DESIGN REVIEW COMMISSION AGENDA

**DESIGN REVIEW COMMISSION
STAFF REPORT**

FROM: TAMI STROUD, ASSOCIATE PLANNER
DATE: JANUARY 25, 2024
SUBJECT: DR-1-24: REQUEST FOR THE FIRST MEETING WITH THE DESIGN REVIEW COMMISSION FOR A PROPOSED SIX-STORY MARRIOTT HOTEL IN THE DC (DOWNTOWN CORE) DISTRICT

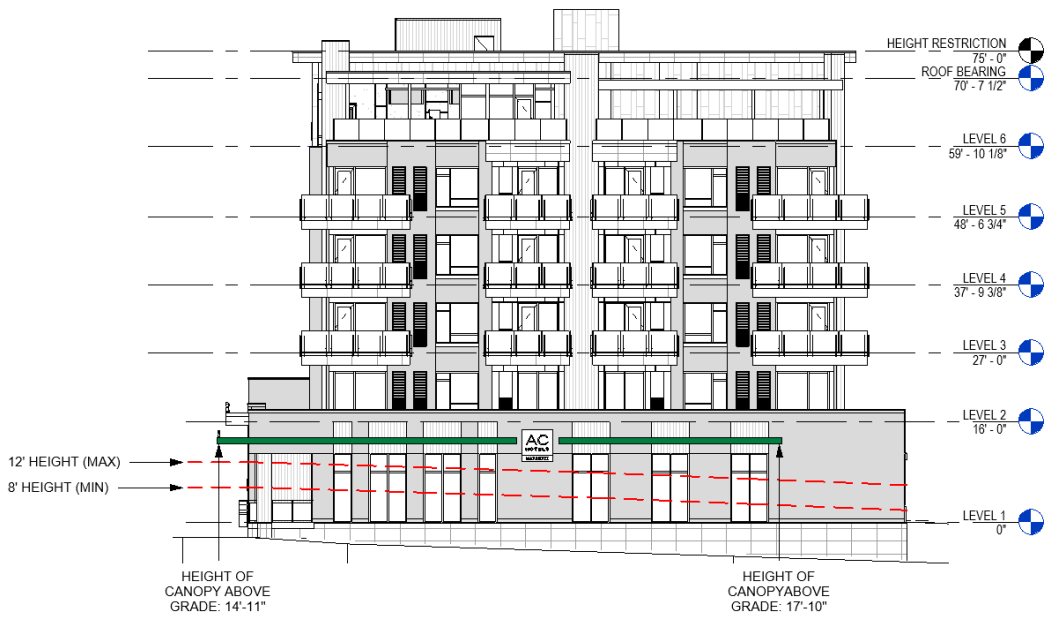
Tami,
On behalf of the developers of the AC Hotel Marriott at 602 & 612 E Sherman Avenue, I would like to apply for a design departure from the Downtown Coeur d'Alene Design Guidelines in regard to the Weather Protection section.

"The Vertical dimension between the underside of a canopy or awning and the sidewalk shall be at least 8 feet and no more than 12 feet."

Starting near the northeast corner of our project, along Sherman Avenue, the canopy height starts at 9 feet 11 inches above the sidewalk, well within the design guideline range. To maintain clearance for any pedestrian and vehicular safety signage that will need to be suspended from the canopy above the parking garage entrance, the height of 9 feet 11 inches established. As the canopy extends west along Sherman Avenue, the sidewalk slopes down at an average of 2.8%. Due to this slope, the height of the canopy increases to 14 feet 11 inches at the northwest corner of the project, which is 2 feet 11 inches above the maximum allowable height in the guideline. I therefore request a design departure to allow a portion of the canopy to extend above the 12 foot maximum as described in the design guidelines based on the following opinions:

1. The canopy as designed meets the intent of the design guideline by providing pedestrians with cover from rainfall and snow.
2. The canopy as designed remains horizontal along the facade and does not change height (except at the hotel's main entrance), aesthetically it does not have a detrimental effect on nearby properties or the city as a whole.

3. The canopy as design covers 94% of the façade along Sherman Avenue and 81% of the façade along 6th Street. The Design Guidelines do not dictate how much of the façade needs to be covered with Canopy. With over 85% of the Sherman and 6th Street facades covered with canopy, this project offers a significant improvement over what otherwise could have been built under minimum standards and guidelines.

4. The Canopy as designed fits aesthetically with the whole of the building. The strong horizontal plane of the canopy helps define the base of the building which is an important aspect of the design guidelines.

5. If the canopy were to step down with the grade along Sherman Avenue and 6th Street to maintain the maximum and minimum height requirement of the guidelines, the canopy would eventually intersect the exterior windows of the project on the main level and would adversely affect the interior daylight experience from individuals inside the project. From the exterior, the stepping down of the canopy along the slope of the sidewalk would adversely affect the aesthetic quality of the architecture.
